Memorandum

Re: Addendum to SD-18-00001 Williams (Shoreline Development Permit Application)
GP-18-00018 Williams (Grading Permit Application)

Manastash Creek Bridge & Driveway at Williams Property

BASIS OF DESIGN DRAWING 2

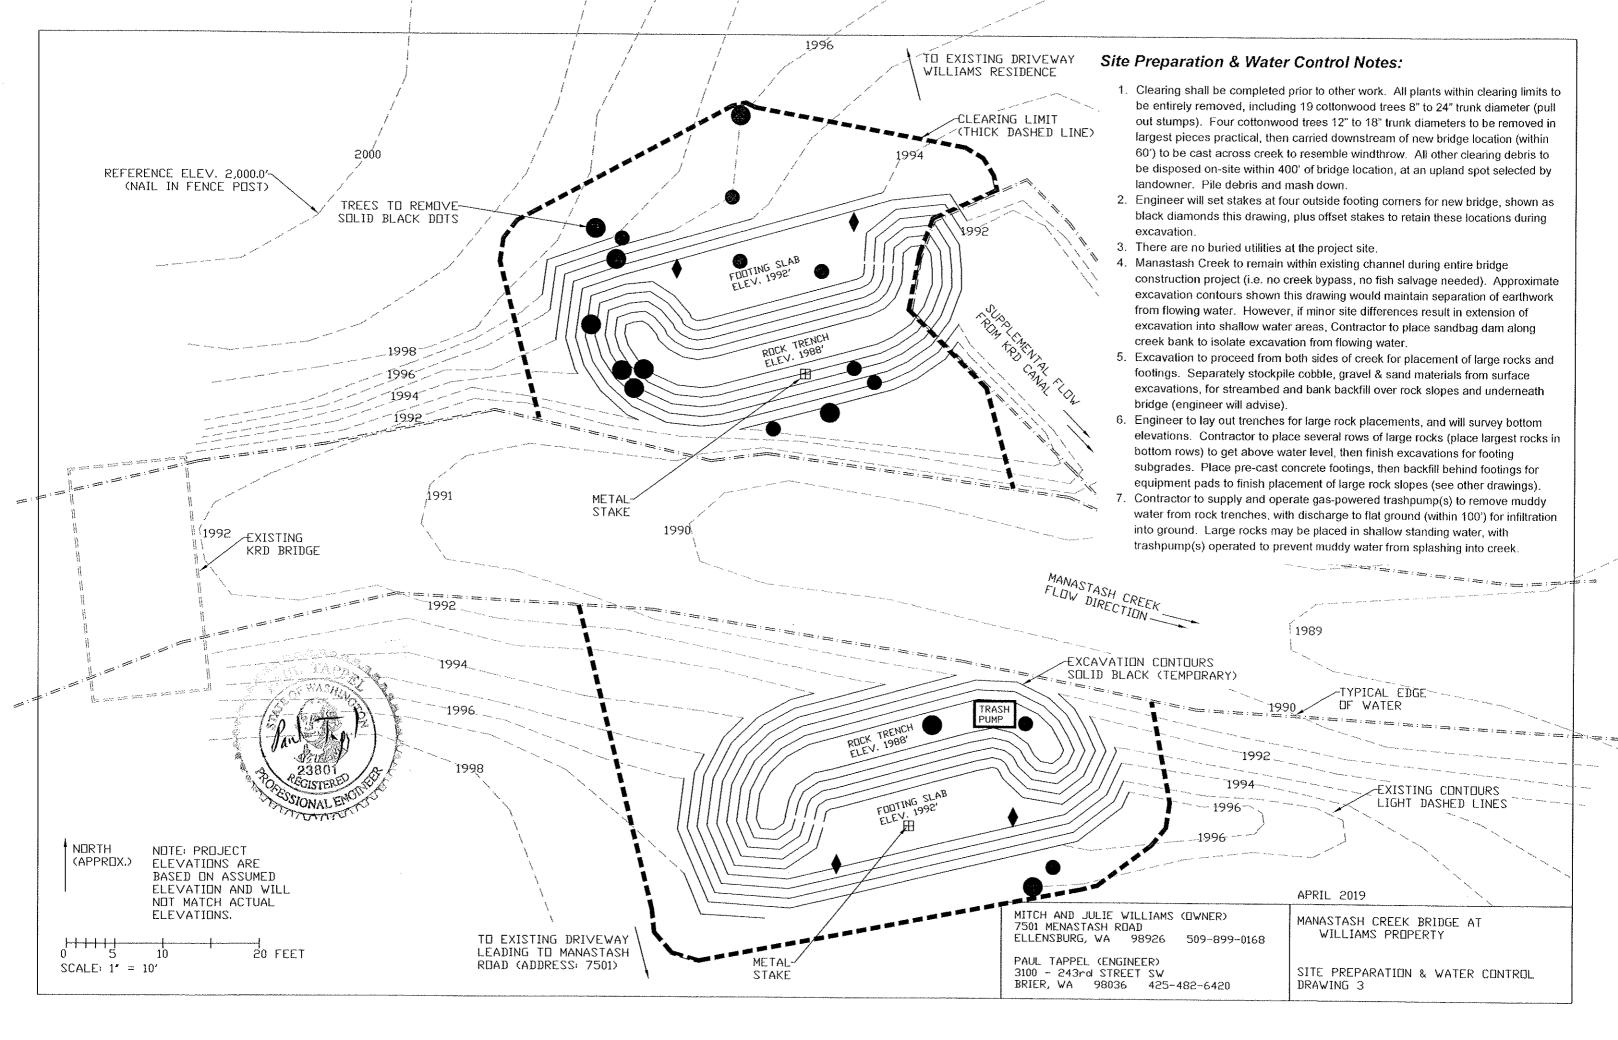
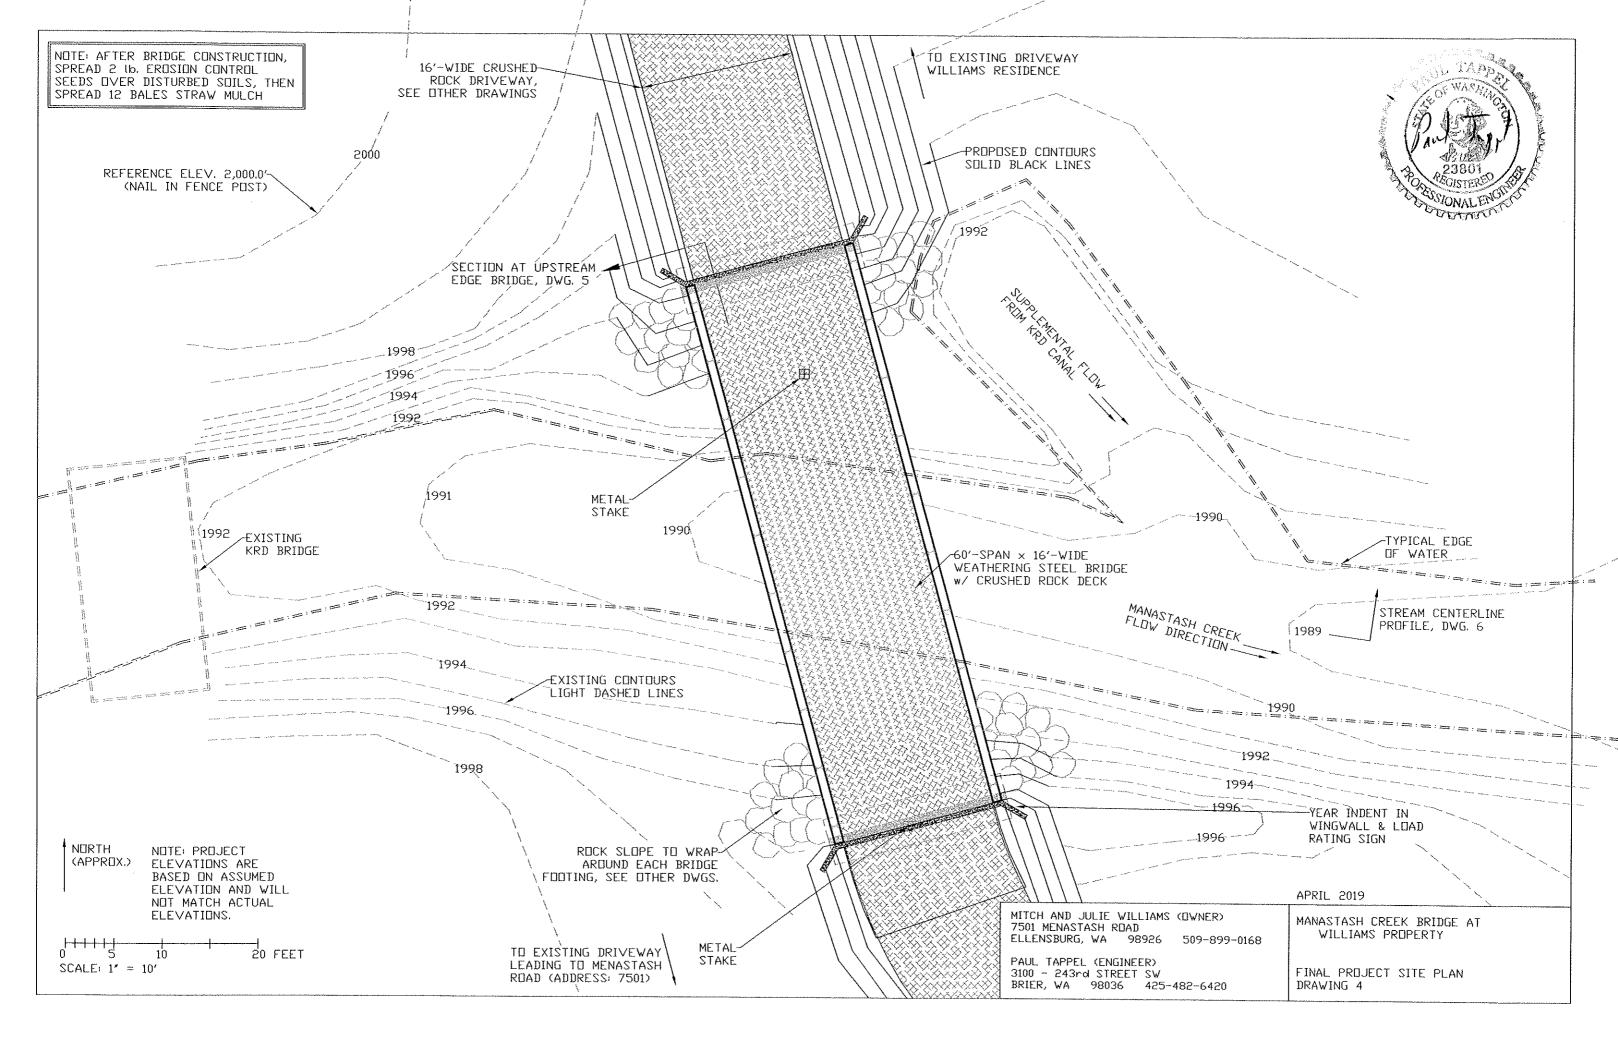
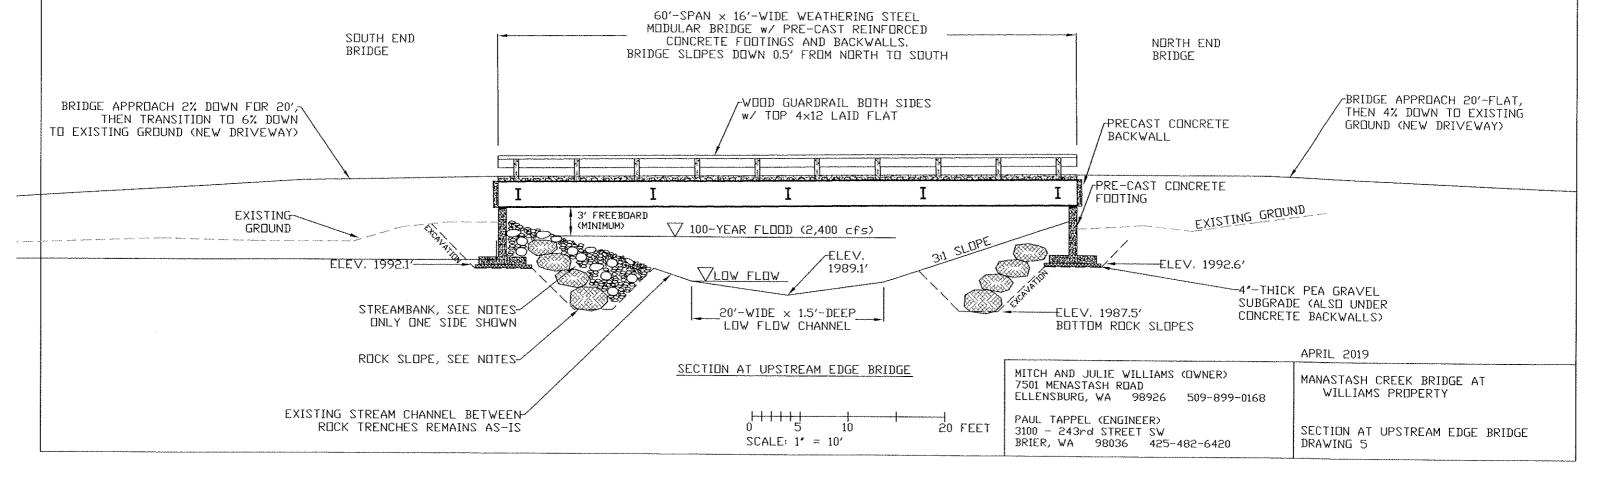
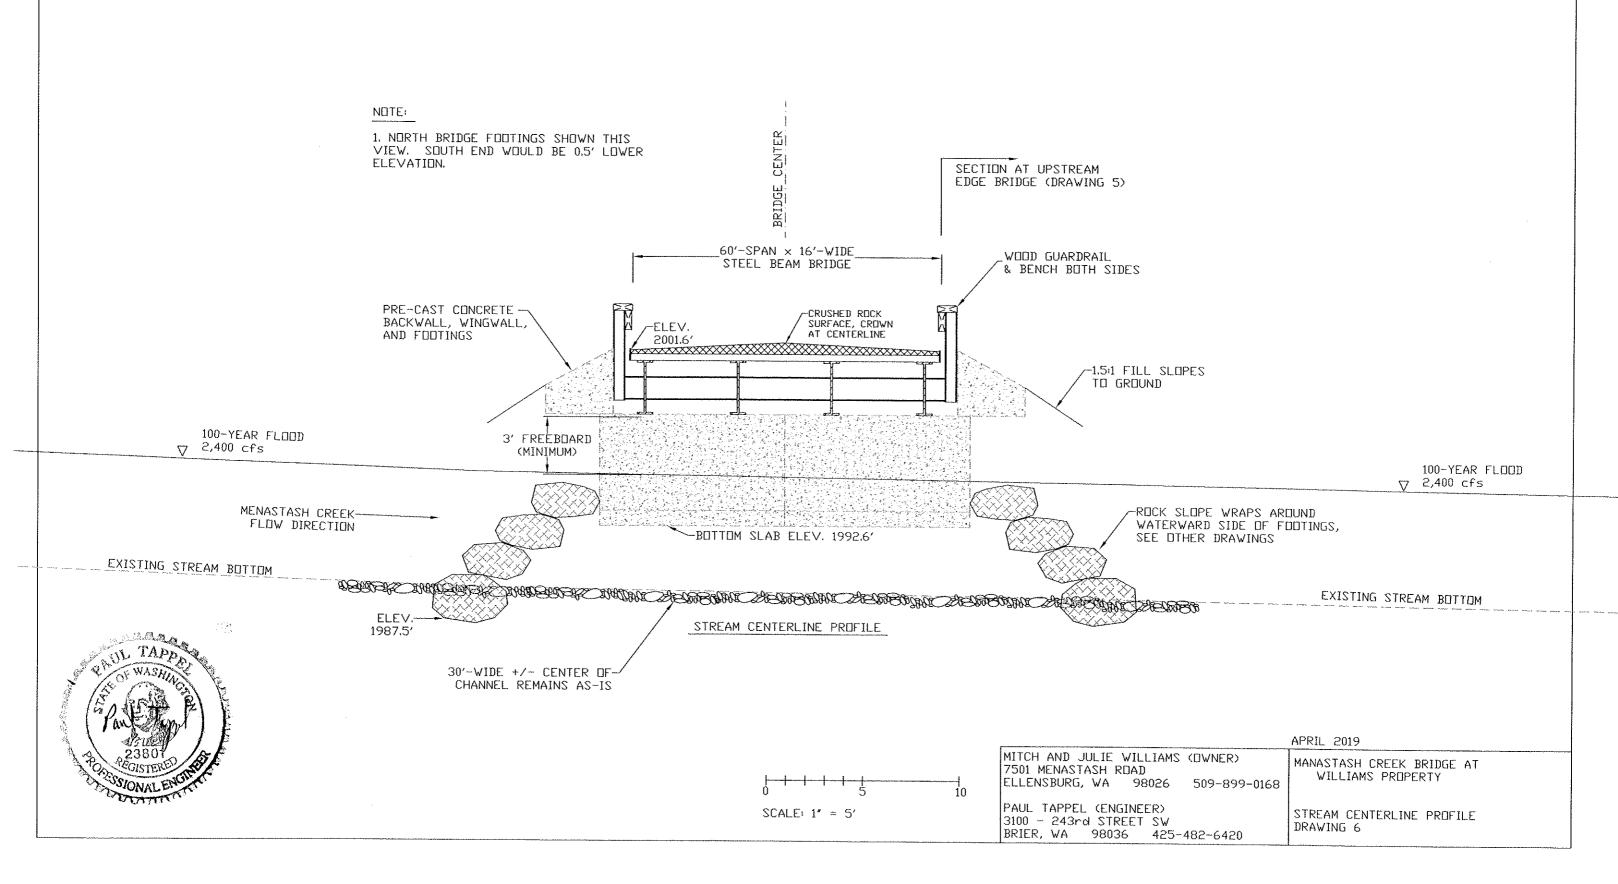
- Bridge deck will be 16'-wide (open) between wood rails, and the entire proposed driveway will be 16'-wide.
- > Bridge design drawings, and driveway site plan, profile & sections are all in one drawing set now, instead of split into two drawing sets.
- A few additional notes are listed on Drawing 2 (Basis of Design) to combine the proposed bridge with driveway design, floodplain considerations, etc.
- All drawings are dated April 2019, and this drawing set completely replaces previous drawing sets.
